## BERNINA Firmware Release BERNINA 7 series V34.05.30

Steckborn, February 12, 2014

### Information on firmware

##### 3.) Service Packs

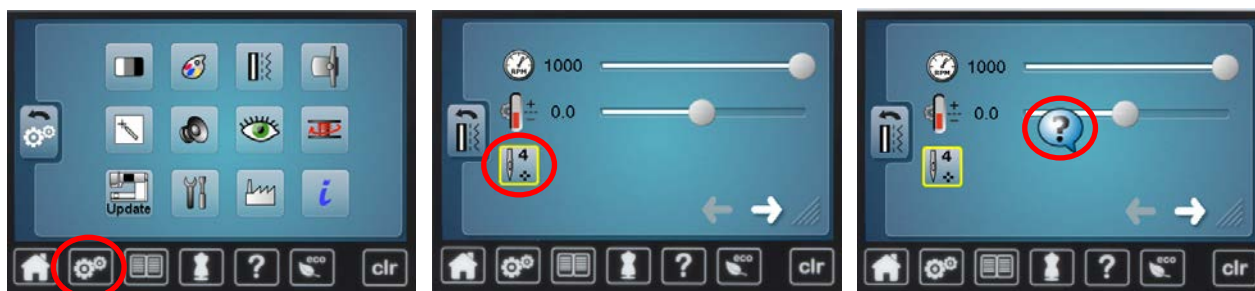
All published service packs up to now have been integrated in this release. Hereby the most important optimizations are:

- Optimization of the thread tension
- The blinking of the icon concerning the filling status of the lower thread when the bobbin is full has been corrected.
- Starting to embroider (refer to issue 7 below for further details)
